# UNITED STATES PATENT AND TRADEMARK OFFICE

APPLICATION NO.	FILING DATE	FIRST NAMED INVENTOR	ATTORNEY DOCKET NO.	CONFIRMATION NO.
10/532,262	09/27/2005	John Mak	100325.0200US	8645
24392 7590 02/04/2009 FISH & ASSOCIATES, PC ROBERT D. FISH 2603 Main Street Suite 1050 Irvine, CA 92614-6232				
EXAMINER				
WU, IVES J				
ART UNIT		PAPER NUMBER		
1797				
MAIL DATE		DELIVERY MODE		
02/04/2009		PAPER

### Office Action Summary

**DETAILED ACTION**

**Fig. 3**

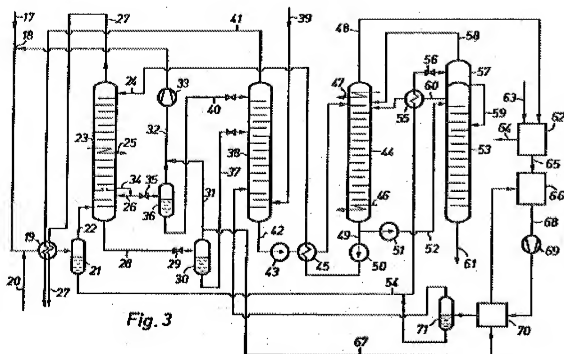
As to an absorber that is configured to receive (a) a feed gas comprising carbon dioxide and hydrogen sulfide, (b) a carbon dioxide saturated lean solvent, and (c) wherein the absorber is further configured to produce an overhead vapor comprising at least a portion of the carbon dioxide in **independent claim 7**, Zeller et al (US 4425317) disclose recycle of hydrogenated sulfur plant tail gas to sour gas scrubbing system (Title). It is shown in the Figure below:

Separator 38 as shown in the Figure above, has input line 40 as recited: To prevent hydrogen sulfide from escaping at the top of the hydrogen-sulfide enrichment column, carbon-dioxide loaded methanol from separator 36 is introduced through the line 40 at the top of the column 38 (Col. 7, line 16-20), input line from separator 71 as recited: the dewatered hydrogen tail gas is then fed into the lower section of the hydrogen-sulfide enrichment stage 38. Conversely, the sulfur compounds contained in the hydrogenated tail gas (almost solely of hydrogen sulfide) are scrubbed in the tower 38 by means of a countercurrent stream of partially saturated methanol (Col. 8, line 45-55), overhead output line 41 as recited: This incompletely saturated methanol acts as a scrubbing agent for the stripped-out hydrogen sulfide, whereby a sulfur-free stream of gas is removed from the column 38 thru the line 41, this stream consisting essentially of only carbon dioxide and nitrogen and being suitable for discharge into the environment after being heated by the gas stream to be purified in the heat exchanger 19 (Col. 7, line 20-27).

As to a bottom product being reduced in pressure and heated to a temperature sufficient to desorb the carbon dioxide from the bottom product in **claim 8**, Zeller et al (US 4425317) disclose methanol containing all of the hydrogen separated from the gas flow and possibly also the carbonyl sulfide in this gas stream and part of the scrubbed carbon dioxide collects in the sump of the hydrogen-sulfide enrichment column 38 (Col. 7, line 28-32). It would be reduced in pressure because the carbon dioxide is stripped and stripping nitrogen gas with increased temperature in absorption of hydrogen sulfide.

As to at least a portion of the hydrogen sulfide in the desorbed carbon dioxide to be absorbed in a 2<sup>nd</sup> absorber using a portion of the carbon dioxide saturated lean solvent in **claim 9**, Zeller et al (US 4425317) disclose this incompletely saturated methanol acting as a scrubbing agent for the stripped-out hydrogen sulfide, whereby a sulfur-free stream of gas to be removed from the column 38 through the line 41 (Col. 7, line 20-24).
